**COLLEGE OF DUPAGE
REGULAR BOARD MEETING**

McAninch Arts Center (MAC) 153 Classroom Renovation Project General Contractor

This addendum is being issued to update the specifications and provide additional information.

EXHIBIT A – QUESTIONS AND ANSWERS

- ① EXISTING SPRINKLER HEADS TO BE REMOVED. CAP PIPING AND PREPARE FOR NEW WORK.

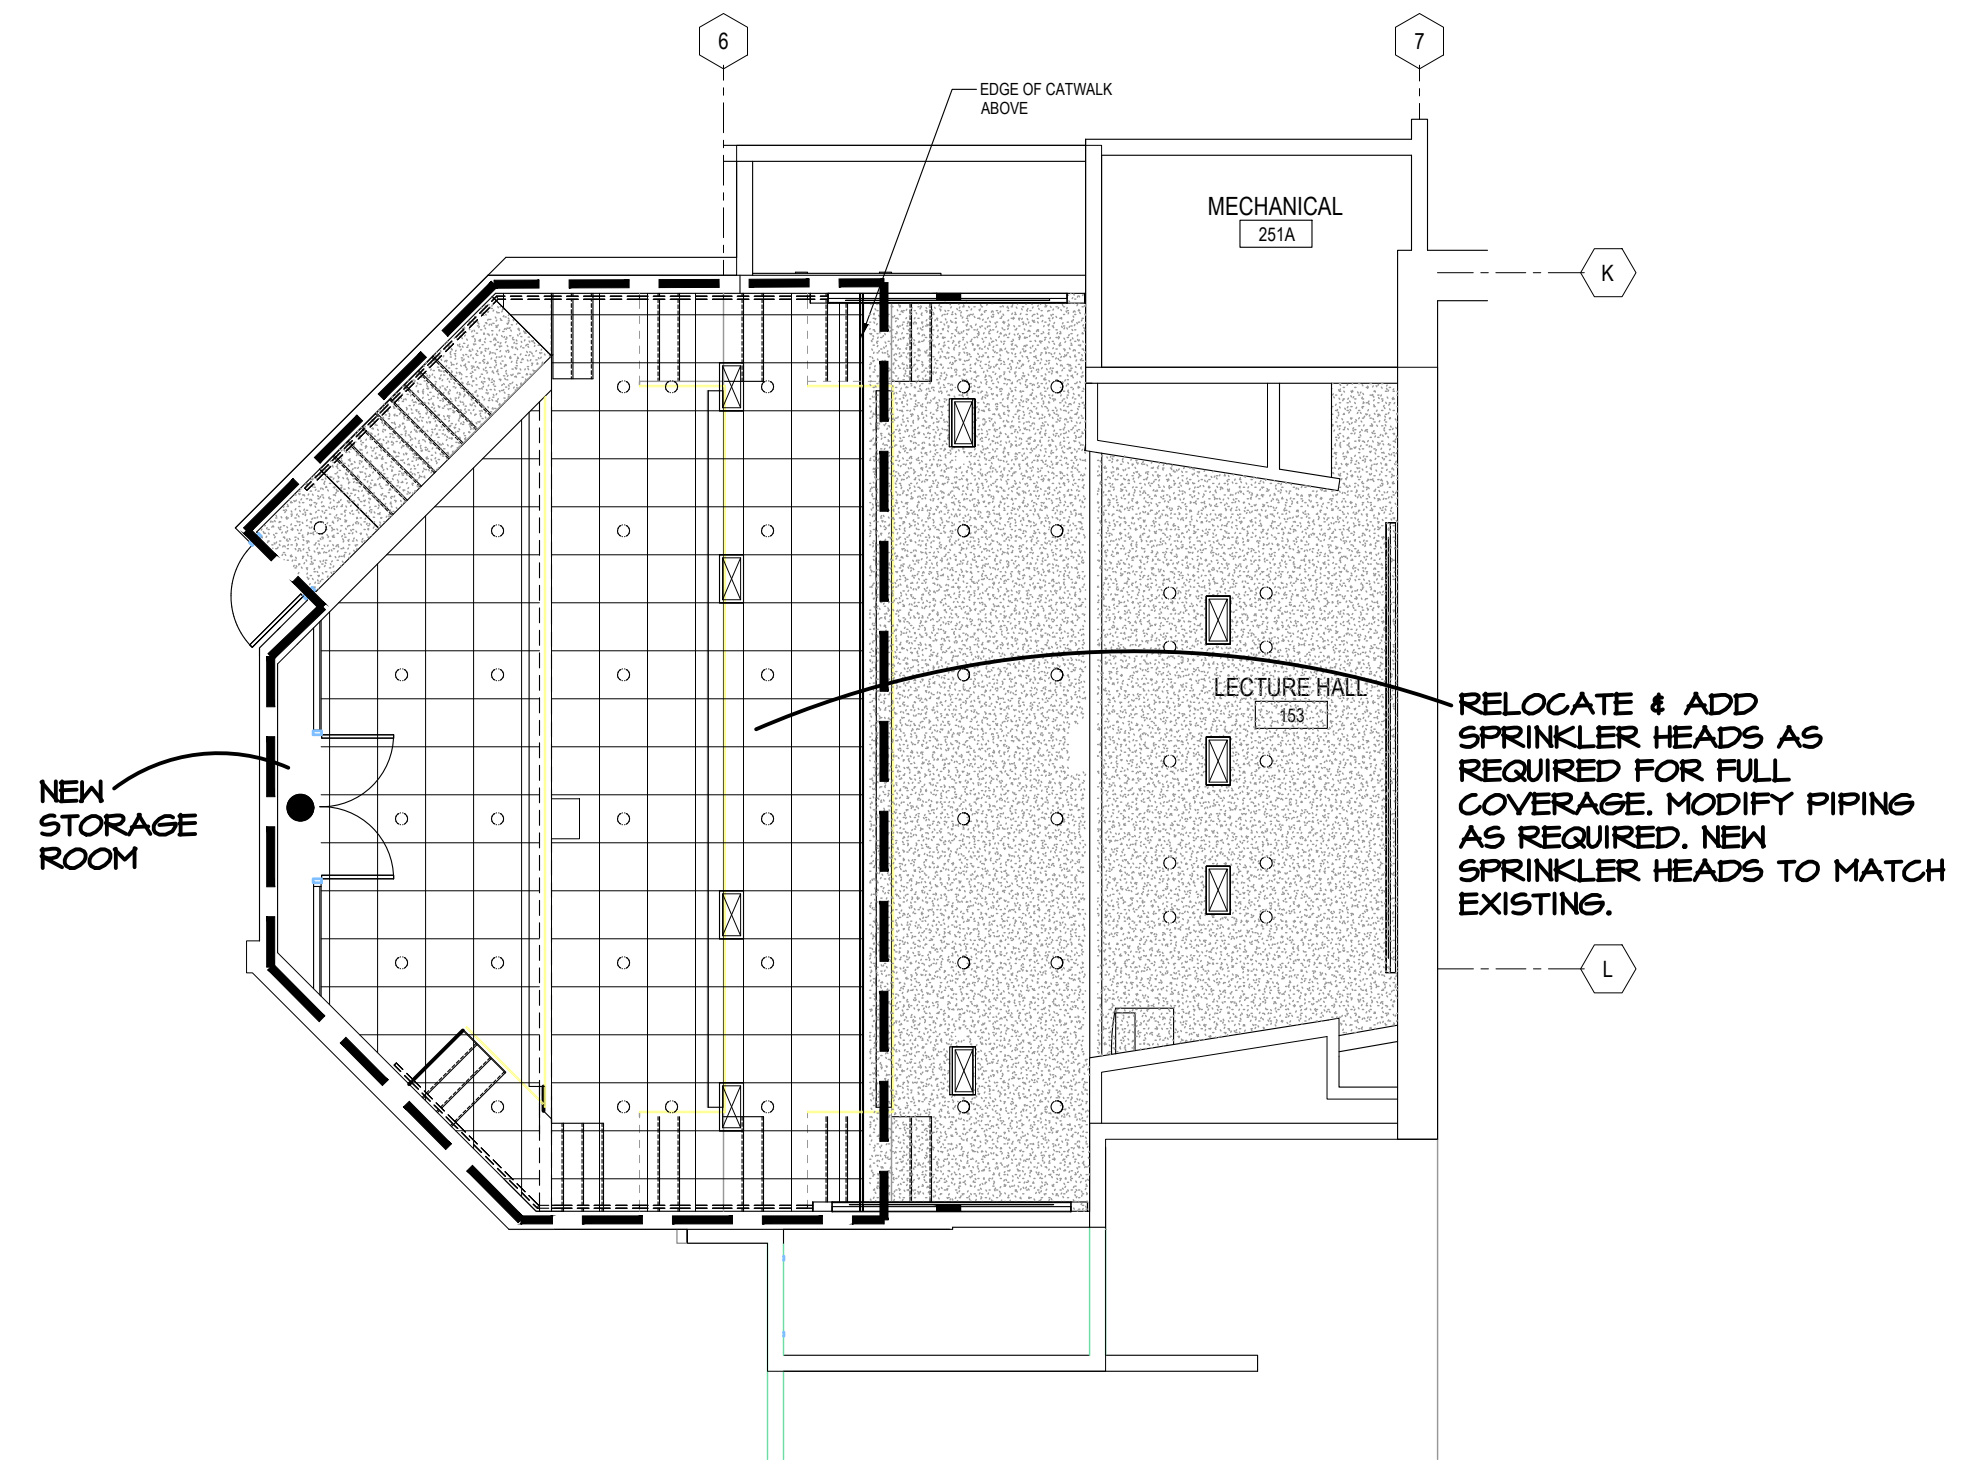
Q4 – Describe HVAC work at the existing control room.

A4 – See revised drawing MFP11-01 issued with this addendum.

A44-02

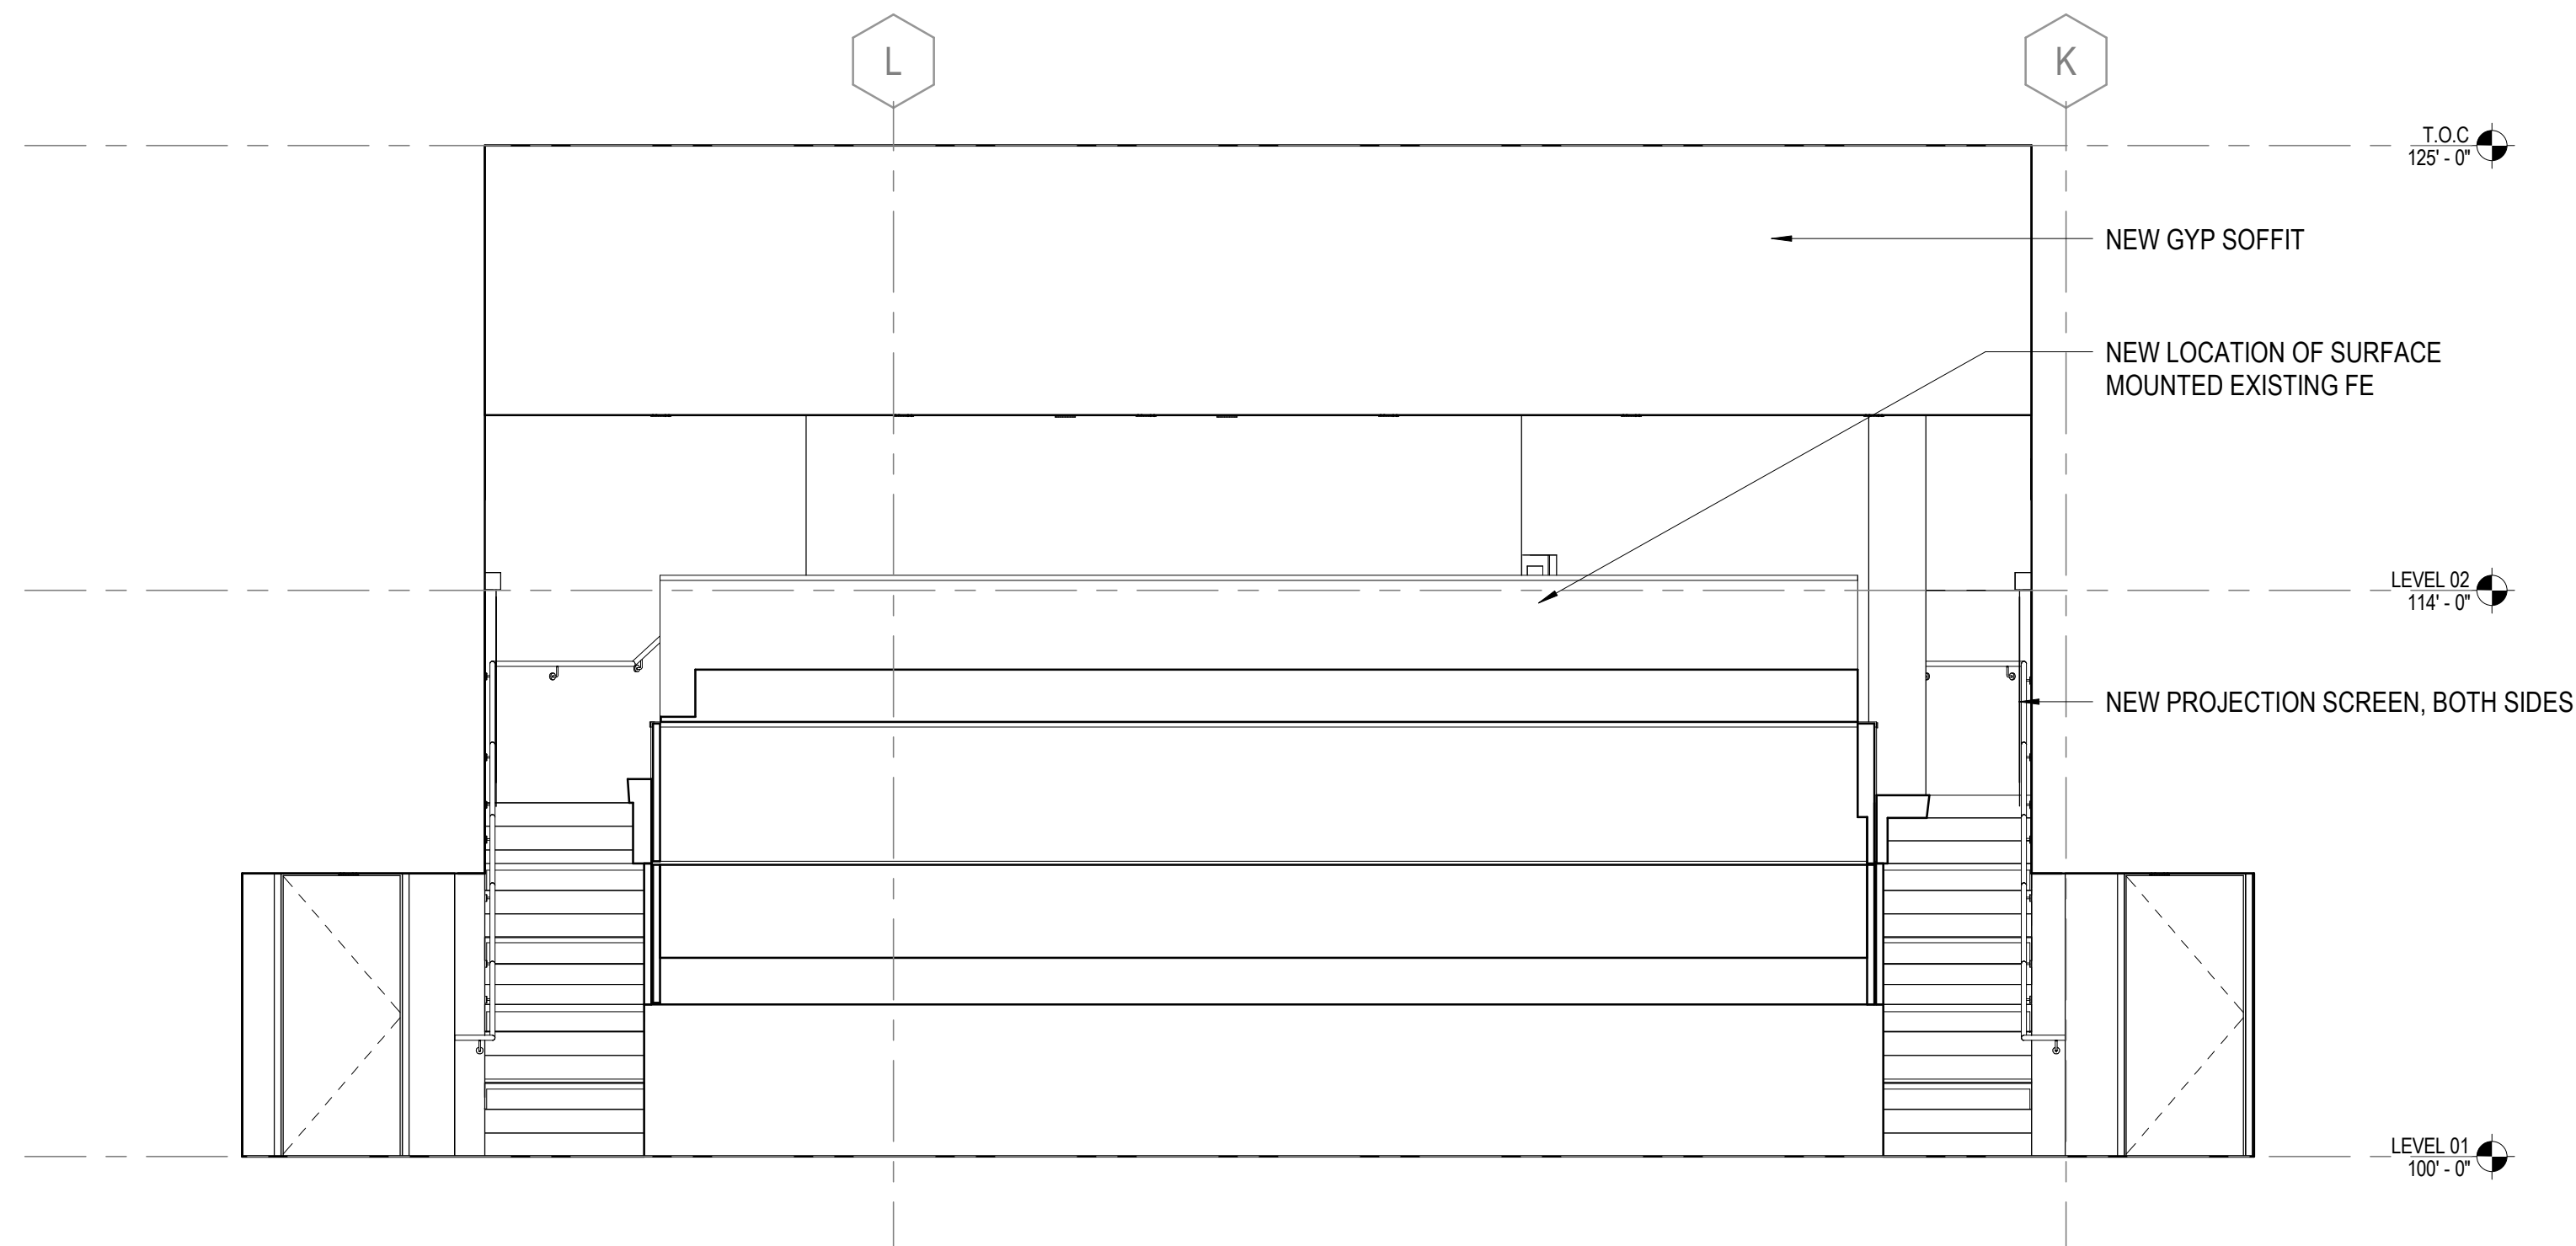
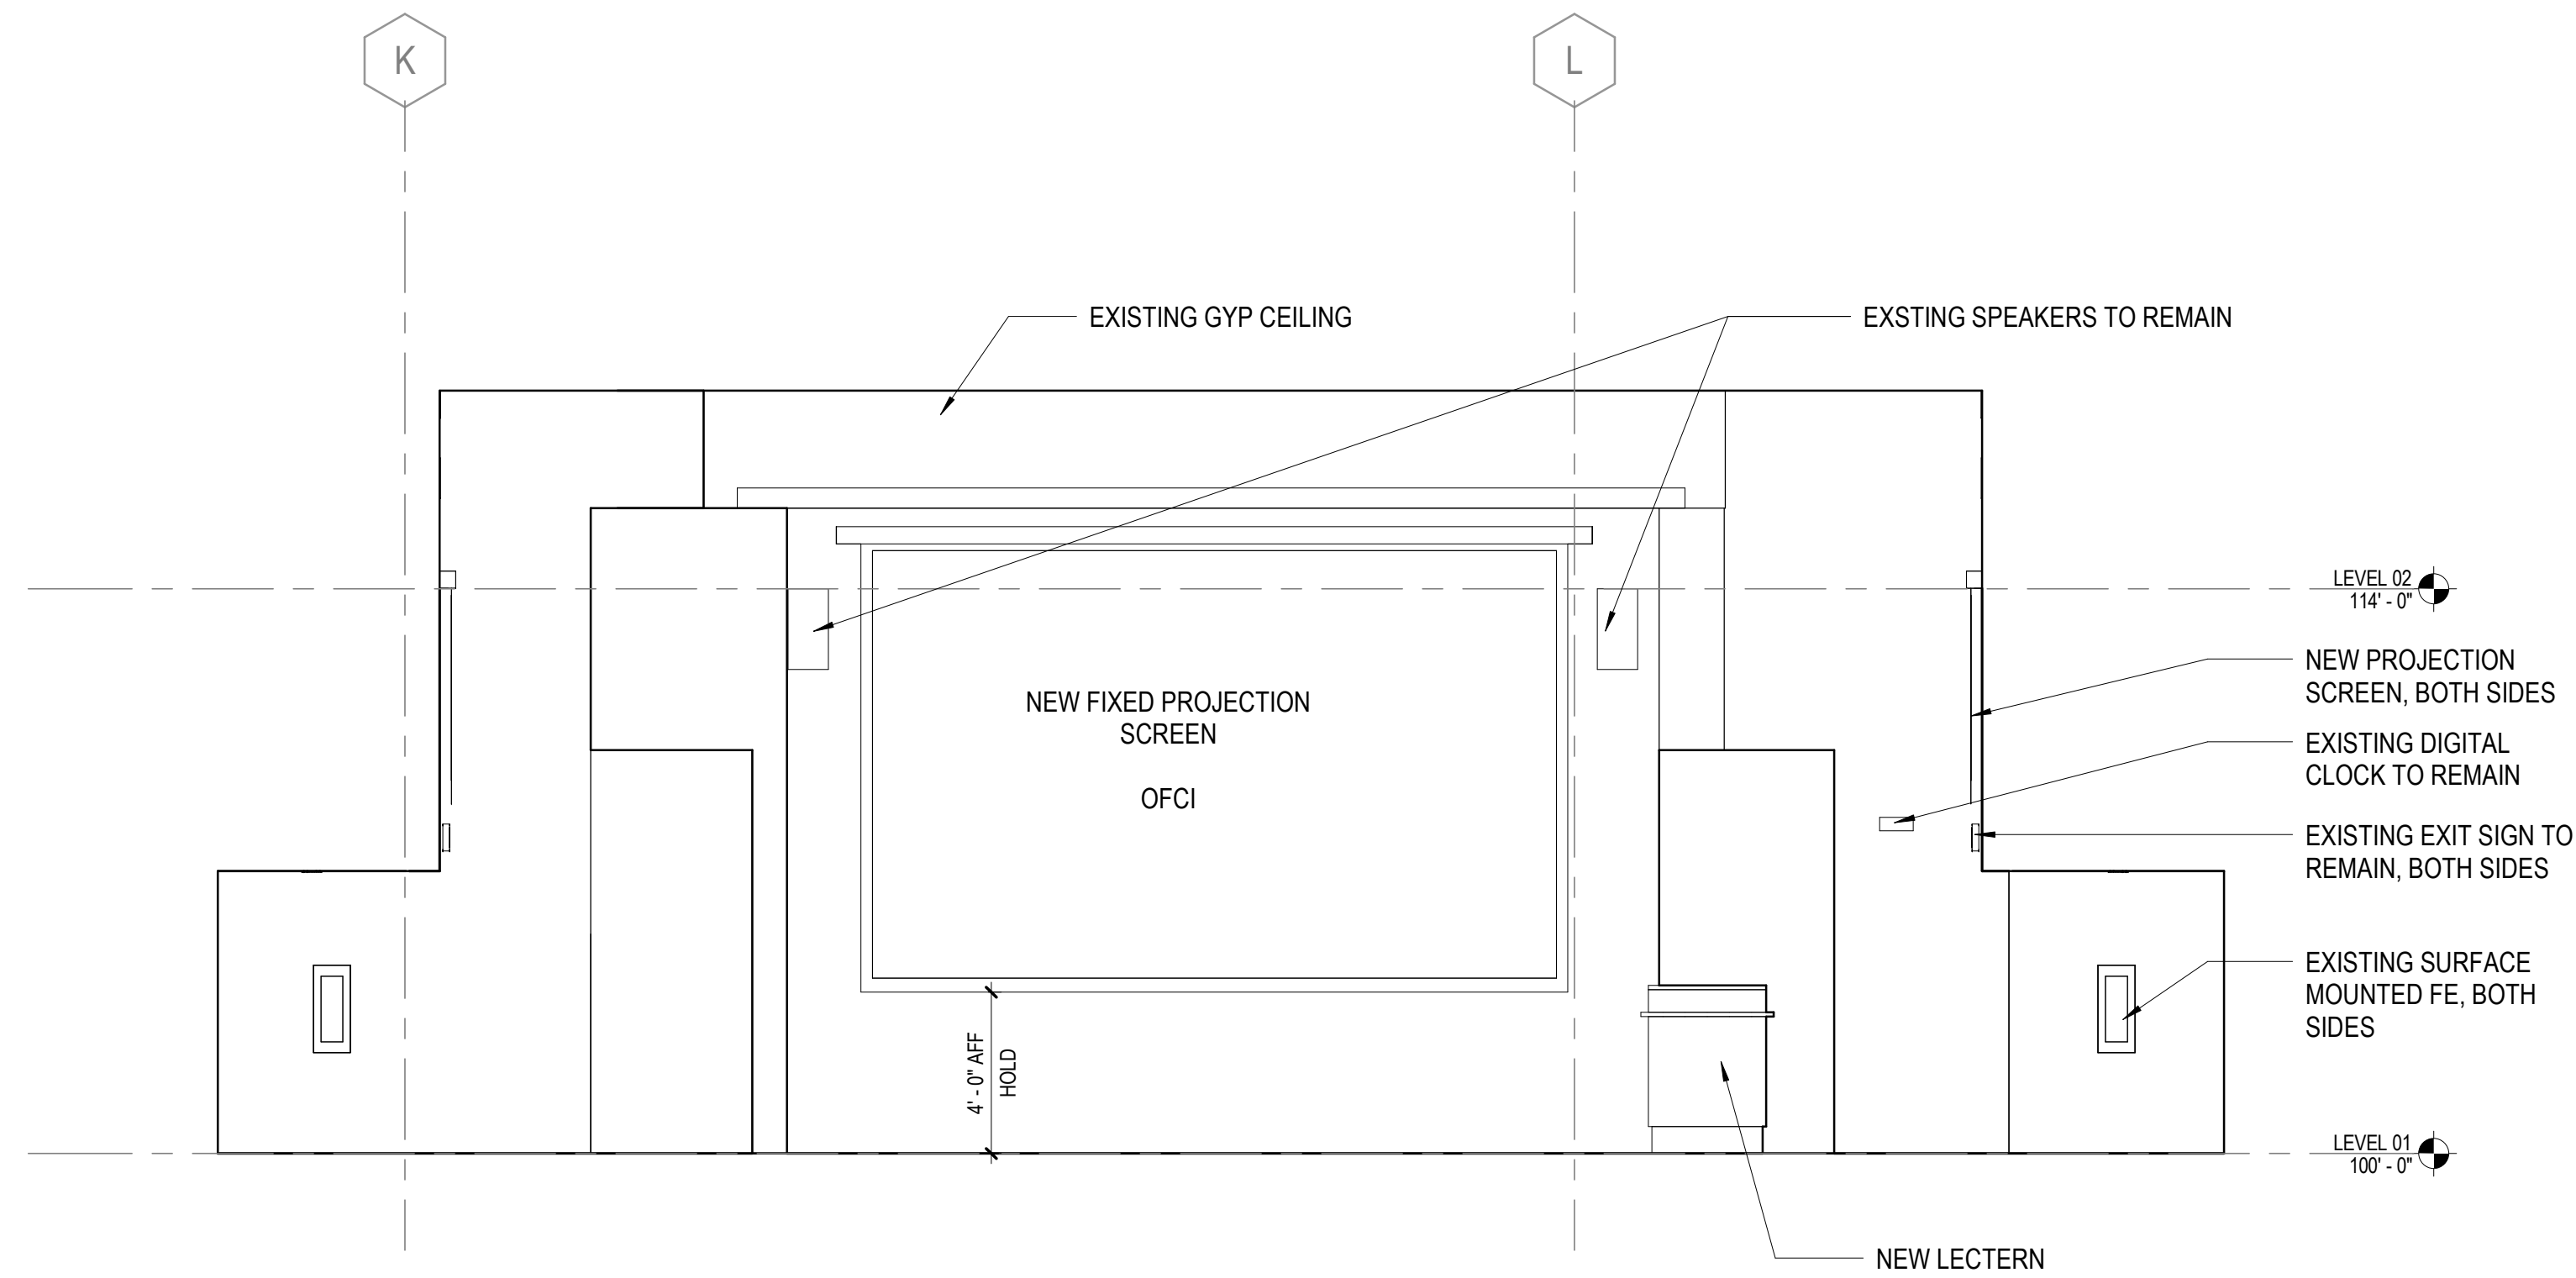
Q3 – Please Provide Room Finish Schedule with the type of flooring used where, as well as the wall covering and paint and base.

A3 – The finishes in the room are described in the drawing tag on 2/!5-01 along with the legend below that drawing. RB-2 is described on 8/A44-01. Wall panels are noted on A44-02.
